Subject: Revision 2 to Ice Condenser Utility Group Topical Report No. ICUG-001:  
*Application of the Active Ice Mass Management Concept to the Ice Condenser  
Ice Mass Technical Specification (TAC No. MB3379)*

Please find enclosed Revision 2 to non-proprietary topical report ICUG-001,  
"Application of the Active Ice Mass Management Concept to the Ice Condenser Ice Mass  
Technical Specification." This revision is submitted by the Ice Condenser Utility Group  
(ICUG) for NRC approval. The methodologies provided in this topical report support  
current and future license amendment request adopting Technical Specification Traveler  
Form (TSTF)-429.

***Application of the Active Ice Mass  
Management Concept to the Ice  
Condenser Ice Mass Technical  
Specification***

**Topical Report ICUG-001, Revision 2**

**Figure O-1. Ice Mass Surveillance Strategy**

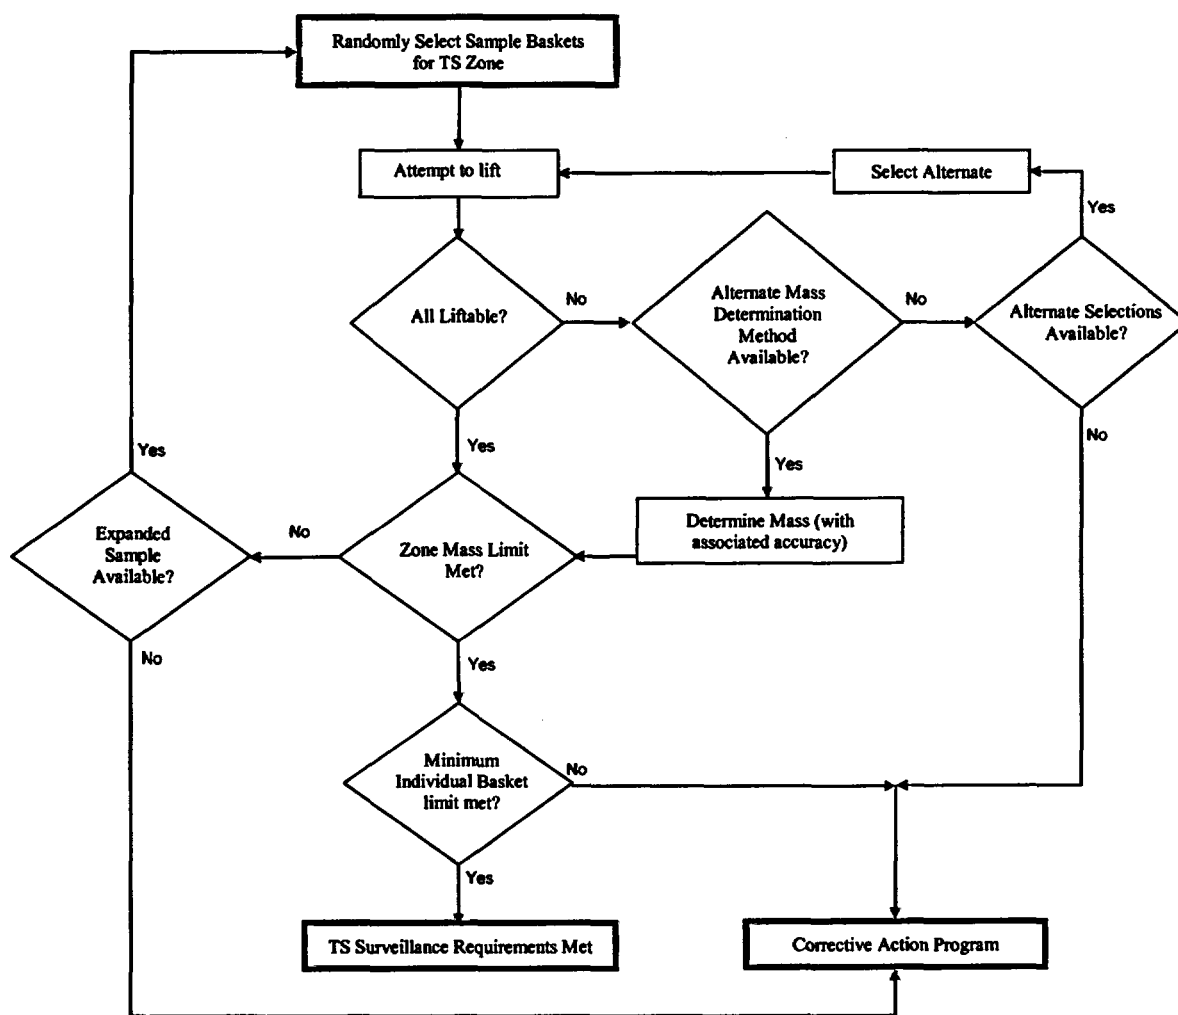
10. Page O-4, **Figure O-1**: Revised term in flow diagram "Blowdown Limit" to "Minimum Individual Basket Limit" per reference 22.
11. Page O-5, **Table O-1**: Revised fourth bullet to: "A surveillance for minimum total ice mass in the bed assures the initial conditions of the DBA analyses". Deleted fifth bullet. Revised sixth bullet to: "A surveillance for minimum ice mass in each individual basket prevents localized degradation to avoid any challenge to the DBA containment pressure response". Revised eighth bullet to: "Proper azimuthal distribution of ice in the ice bed is no longer assessed by a separate surveillance requirement; it is implemented through established industry-wide maintenance practices that manage each ice basket above the required safety analysis mean and confirmed through as-found random sampling techniques". Revised ninth bullet to: "All ice baskets in the parent population are subject to random statistical sampling, as opposed to only two-thirds of the population subject to representative sampling." Changes per references 22 and 27.

**Figure 1-1. Typical Plan View of Containment Building**

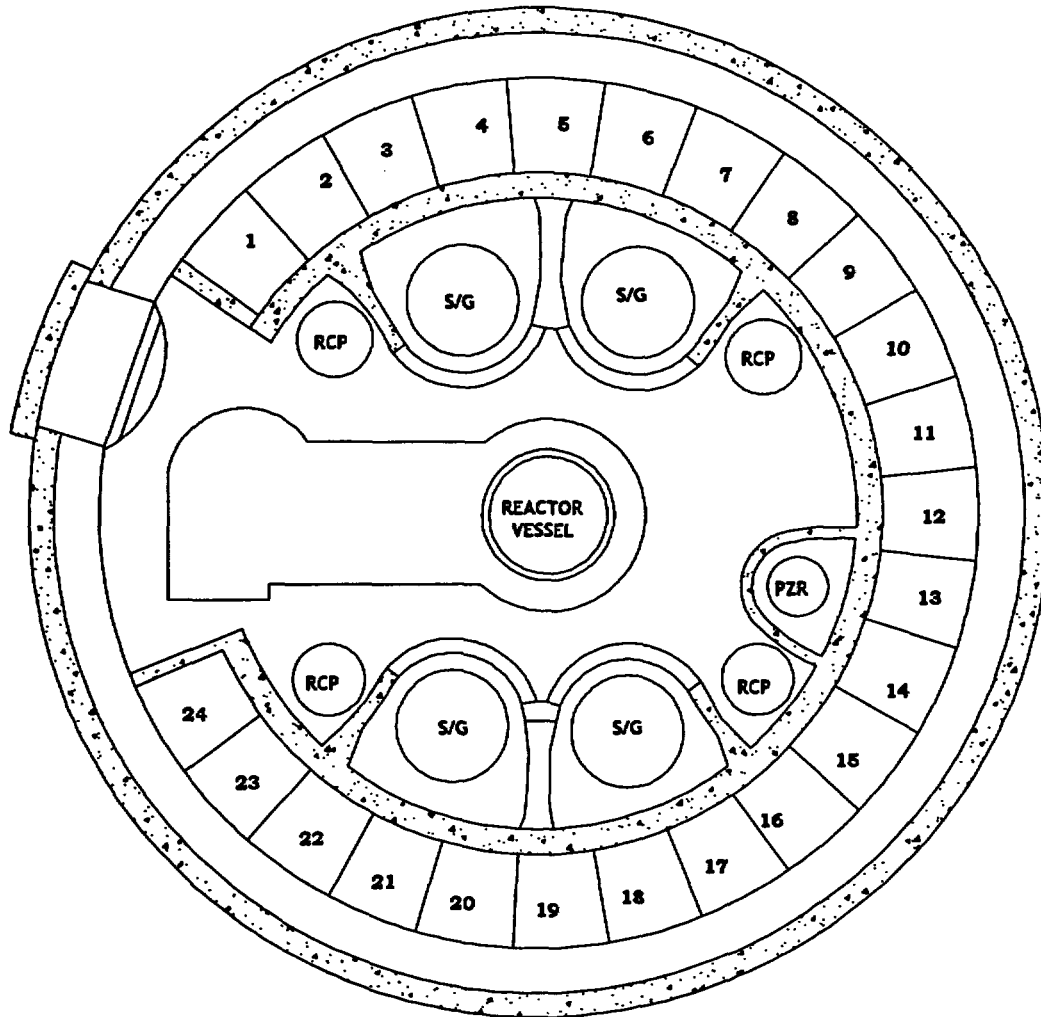
16. **Page I-3, Original Ice Mass Technical Specification Requirements:** Revised paragraph under Figure 1-1 to read: "In addition, these masses were used as the verification that a degraded localized region did not exist in the ice bed that would challenge the DBA pressure response. If a basket in the 144-basket statistical sample was found to weigh less than the required individual limit (described as "light"), the sample was to be increased in the localized region (i.e., the affected Bay) by 20 baskets. The averaged mass of the 20 additional baskets and the "light" basket was then required to meet the surveillance limit". Deleted reference to the long-term phase of the DBA in the last sentence on the page. Changes per references 22 and 27.

**Figure 1-2. Row-Group Sublimation Rates**

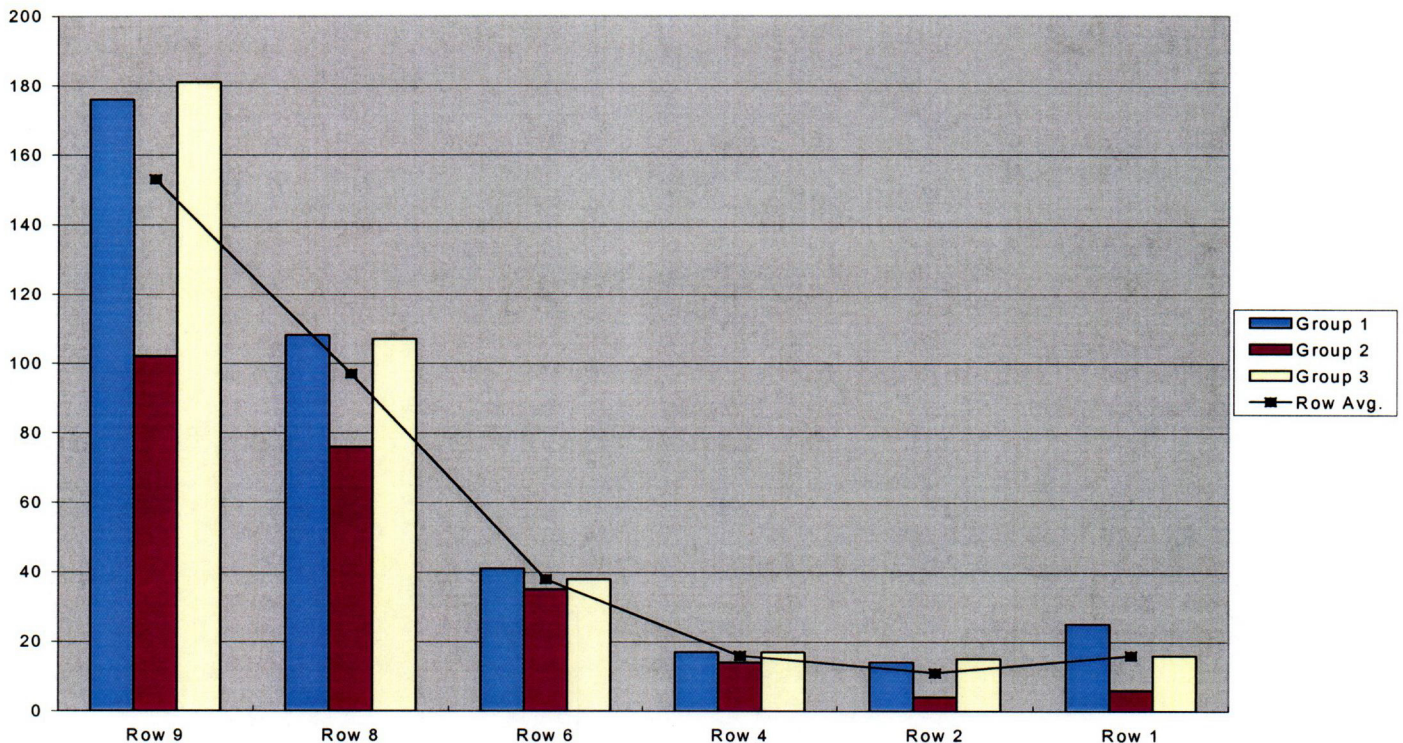
In reviewing Table 1-1 and Figure 1-2 of the topical report, the staff noted that significant differences in sublimation rates appeared among Rows 7, 8, 9 and that more frozen ice baskets exist in Row 9 than in Rows 7 or 8. In RAI No. 3, the NRC staff asked ICUG to explain how the differences and the frozen baskets would affect the accuracy of the weight measurement by using the radial zone concept.

In practice, localized groups of baskets along the same Row will also sublimate at different rates, depending on their proximity to specific heat sources (such as the End Walls). This effect, however, generally extends to the other baskets in the vicinity (see Figure 1-2 in the topical
